**Subject:** Objection Submission for DA2019-0774 at 40 Maxwell Street Mona Vale

**Objection Submission for DA2019/0774 at 40 Maxwell Street Mona Vale**

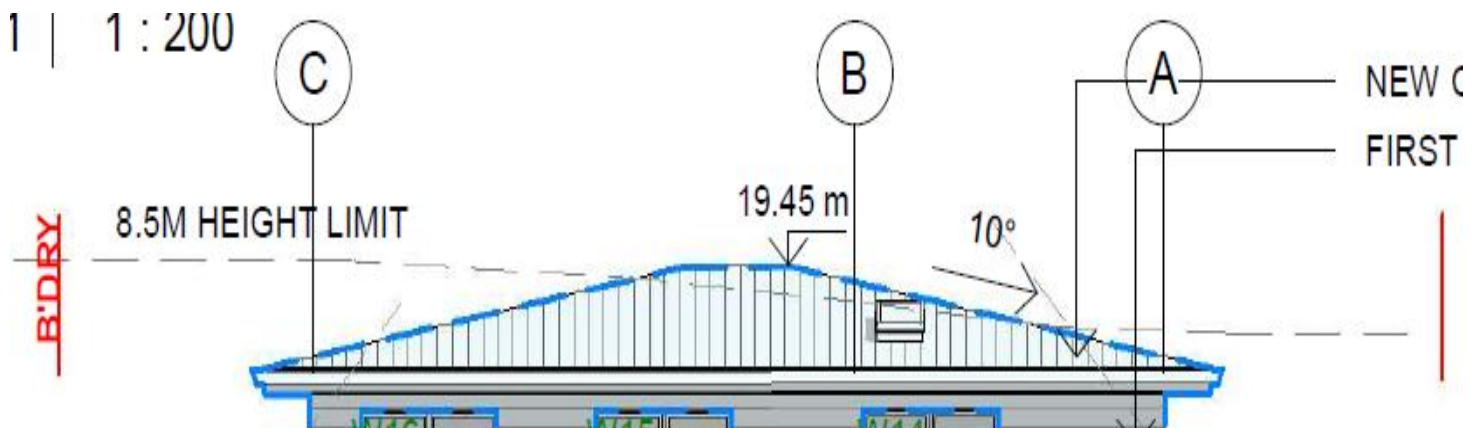
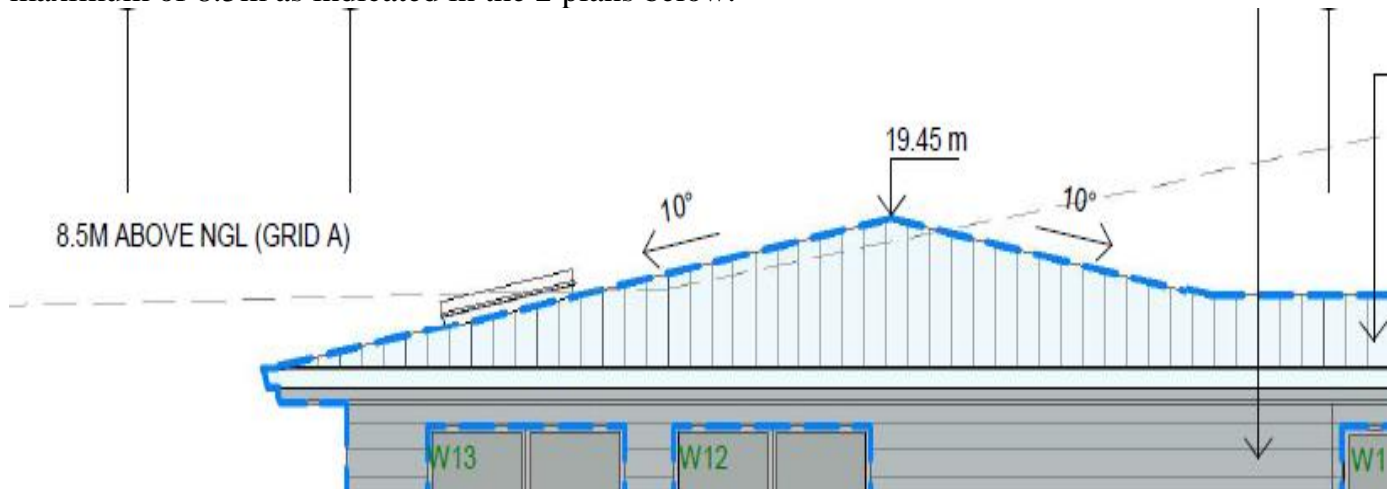
I object to the loss of **Tree 3** and **Tree 4** identified in the Arborist Report, which are located inside of the proposed construction footprint, and the trees cannot be retained under the current proposal. These are shown in red circles in the plan here.

Also there is other vegetation loss identified by the blue circles that I cannot find has been referred to in any report but which is shown on plans submitted and highlighted here as being lost vegetation.

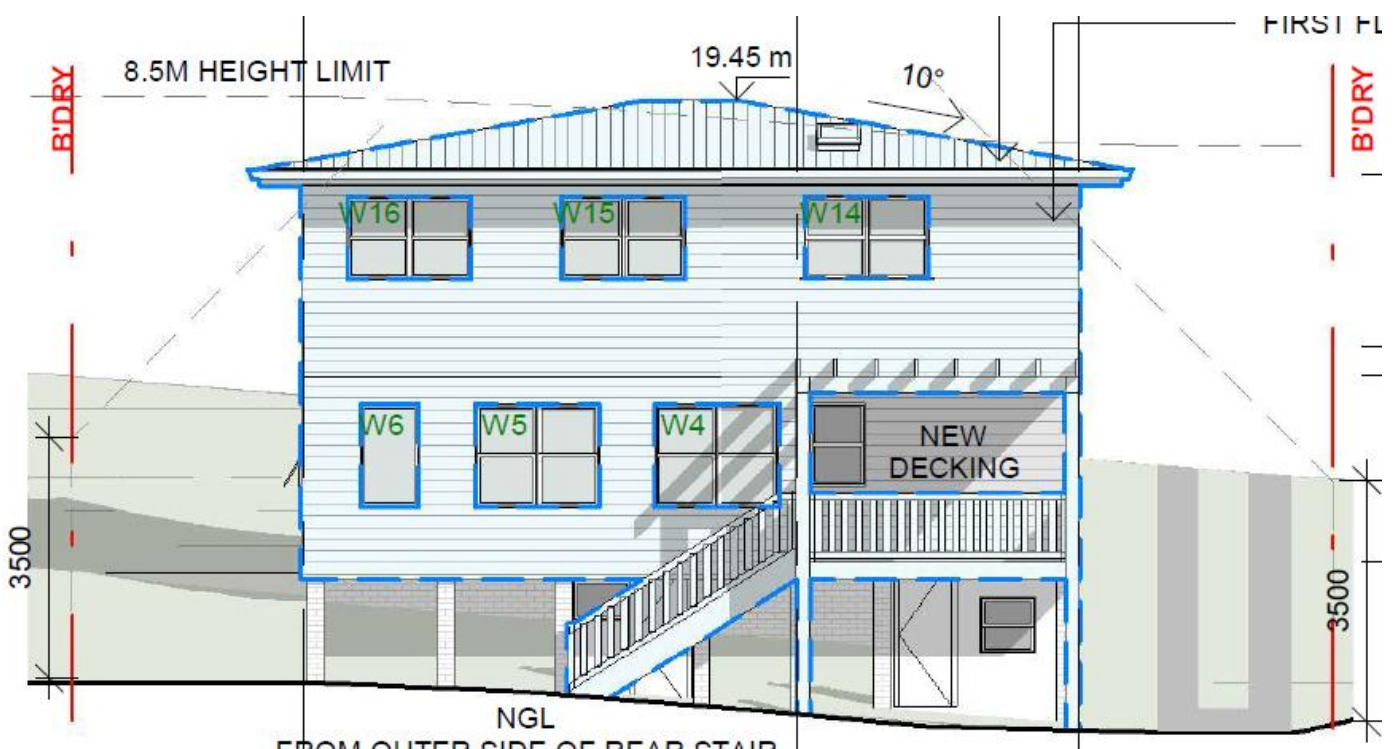
I object that the height of the second storey addition to the principal dwelling exceeds the maximum of 8.5m as indicated in the 2 plans below.

Already the buildings are substantially elevated from the ground and any breach for height must not be approved.

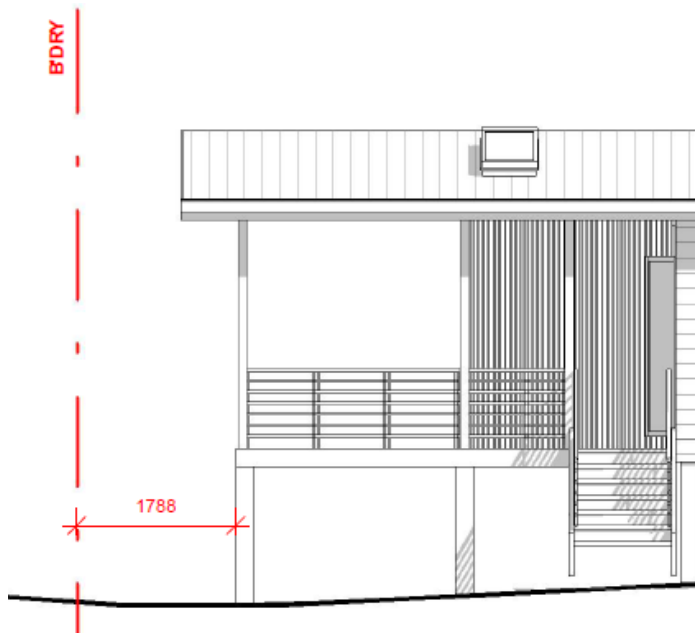
The envelope established by a 45 degree angle drawn 3.5m up on each side boundary and projected through the building indicates non-compliance with this planning control.

The plan below shows both side elevations do not comply.

It should not be approved considering in relation to the principal dwelling the 8.5m height control is breached and the side building envelope control is also breached indicating a poor planning outcome.

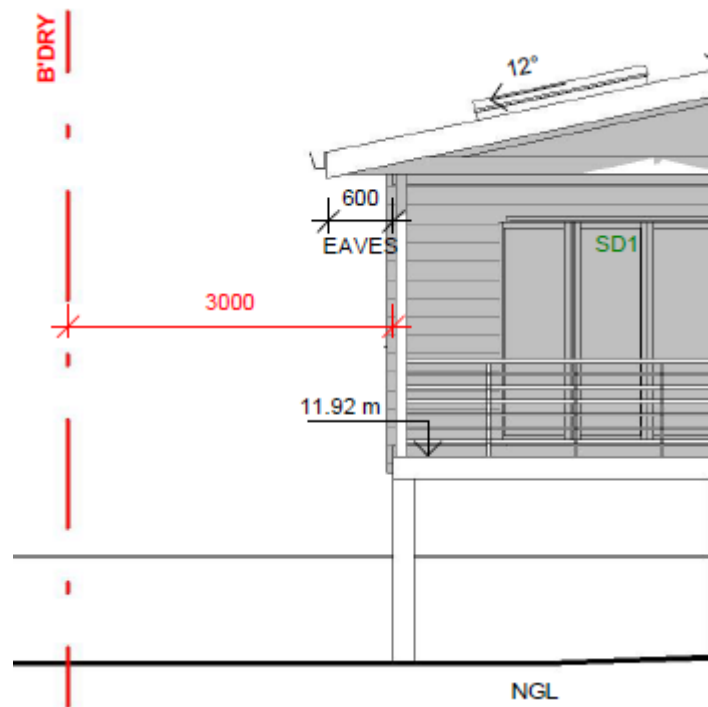
The proposed secondary dwelling has the greatest setback to the northern side boundary, but only achieves 1788mm.

The 3D model below shows an extensive balcony to this boundary and there is no reason why the balcony cannot be reduced in size and pulled back from the boundary to achieve 2500mm.

The proposed 1788mm is not acceptable and the application must not be approved.
